Lane muxing constraints for 800GBASE-R PMA

(in support of comment #6, and pertaining to comments #166, #167)

Adee Ran, Cisco

FLR effect of option B with low error correlation (optics or C2M)

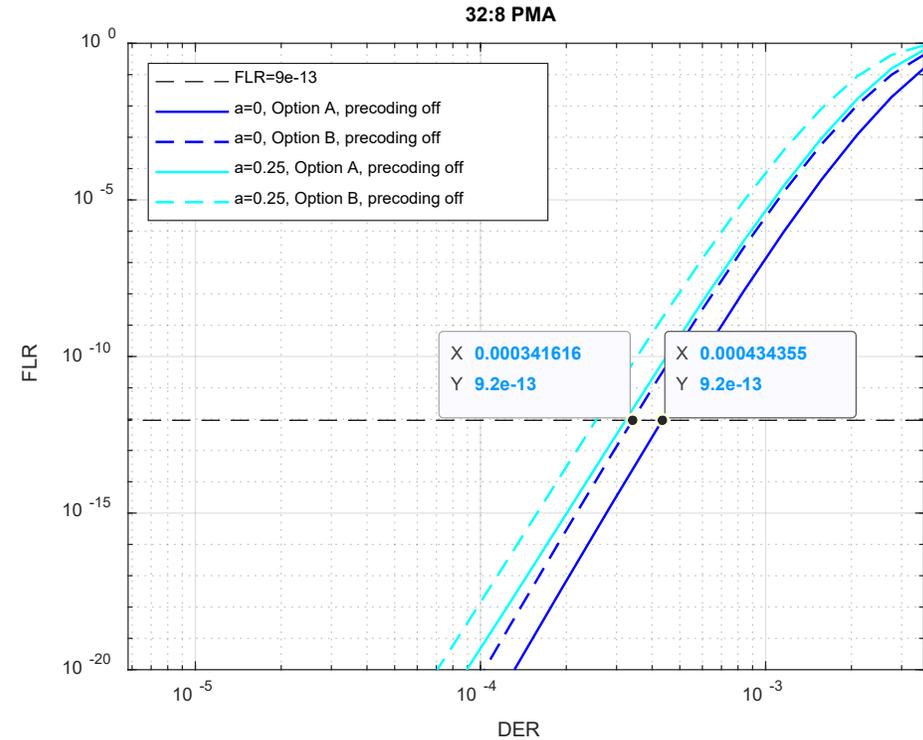
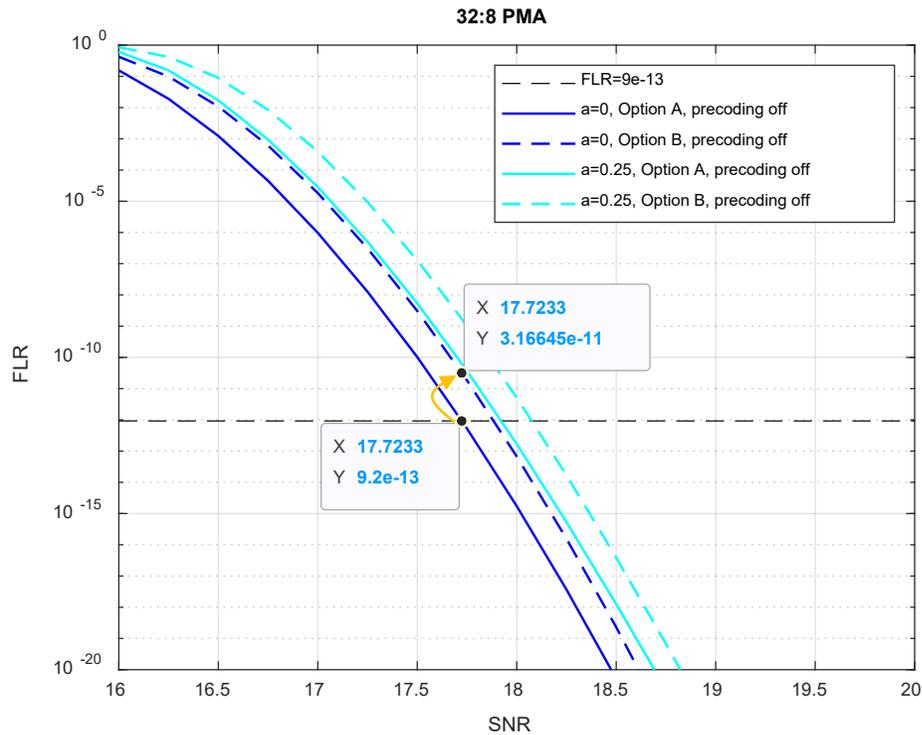
Factor of 34 (1.5 orders of magnitude) increase in FLR, or ~0.15 dB penalty

Reduction of 25% in pre-FEC BER is required

Notes

- The FLR penalty is almost constant (1.5 order of magnitude) regardless of error correlation, so only shown at two values of a
 - Higher values of a will likely cause precoding to be used anyway

- “Option B” does not exist in any 200G/400GBASE-R PHY or AUI
 - The FLR effect ($\times 34$) is worse than that of having 4 instead of 2 codewords ($\times 2$)

- Existing links will have a higher FLR at 800G (with option B) than at 200G/400G
- “Option B” may be susceptible to the “low clock content” issue because the LSBs always come from the same flow (and thus the same scrambler), as in clause 119

- In “Option A” the LSBs alternate between two flows, which seems to solve the issue (the probability of having correlated outputs from two separate scramblers is negligible).

- A PMA(8:8) should be prevented from permuting PCSLs such that “option A” at the input is converted to “option B” at the output.

Suggested remedy (per comment #6)

173.4.2.1 32:8 PMA bit-level multiplexing

Change the second list item as shown:

- The multiplexing function has an additional constraint that each of the 8 output lanes contain two unique PCSLs from PMA client lanes $i = 0$ to 15 [encoded as one PAM4 symbol](#), and two unique PCSLs from PMA client lanes $i = 16$ to 31 [encoded as the subsequent PAM4 symbol \(see 173.4.7\)](#).

Option X (unconstrained muxing)

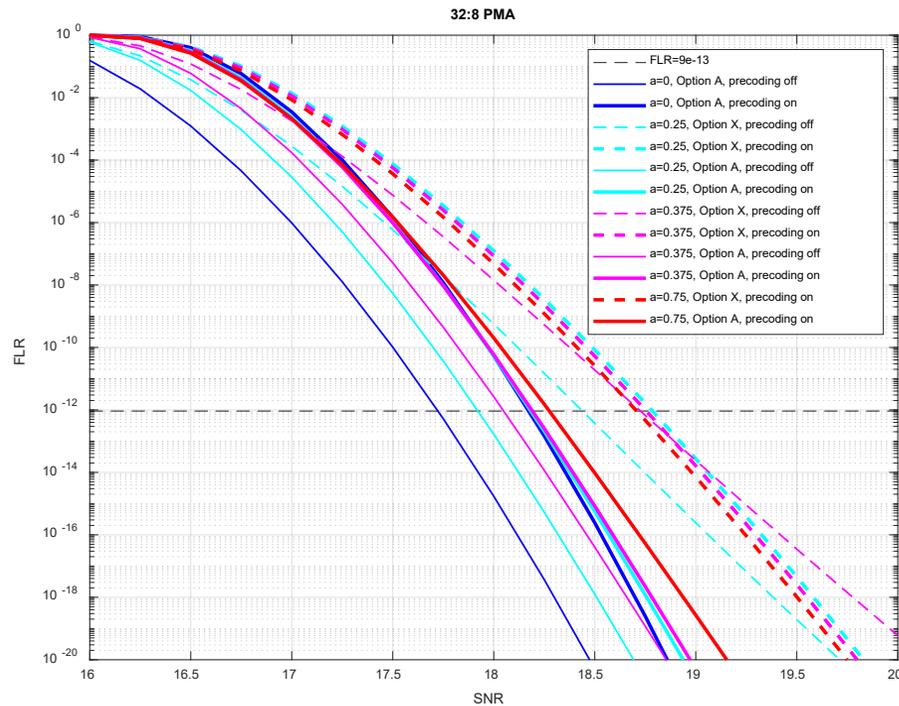
Each PAM4 symbol contains two bits from the same flow, but each lane has only one flow.
This muxing does not adhere to the constraint.

Short bursts can corrupt 4 symbols in the same codeword
Immunity to correlated errors is worse than in 200G/400G

Effect of option X

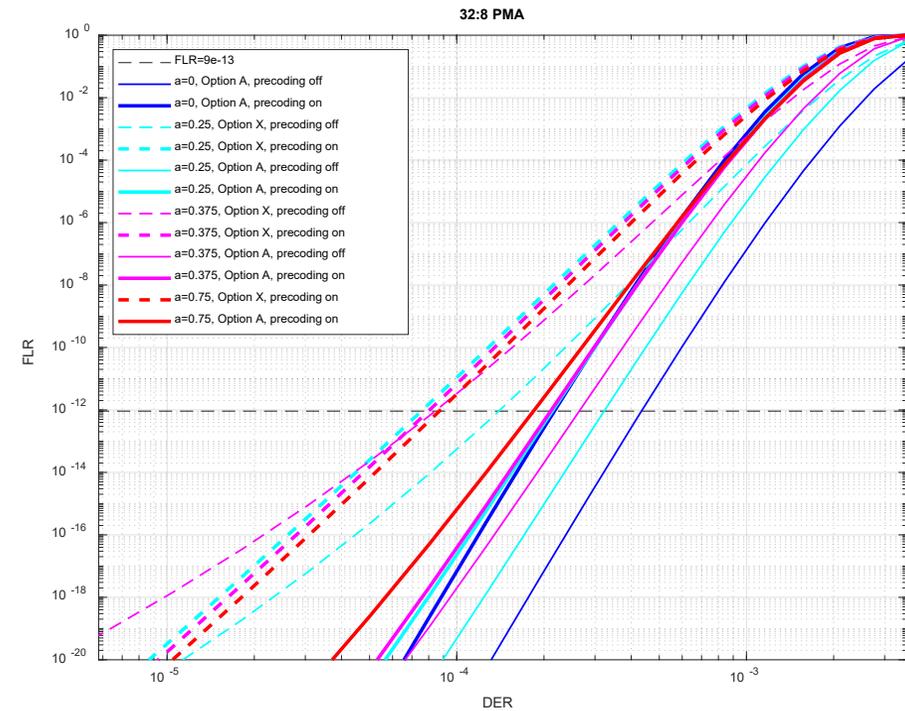
(Compare dashed lines to solid lines)

Large SNR penalty for any $a > 0$

Large minimum DER effect for any $a > 0$

- The constraints on lane muxing should be retained.
- Additional constraints are proposed to prevent degraded performance due to bad muxing choice.
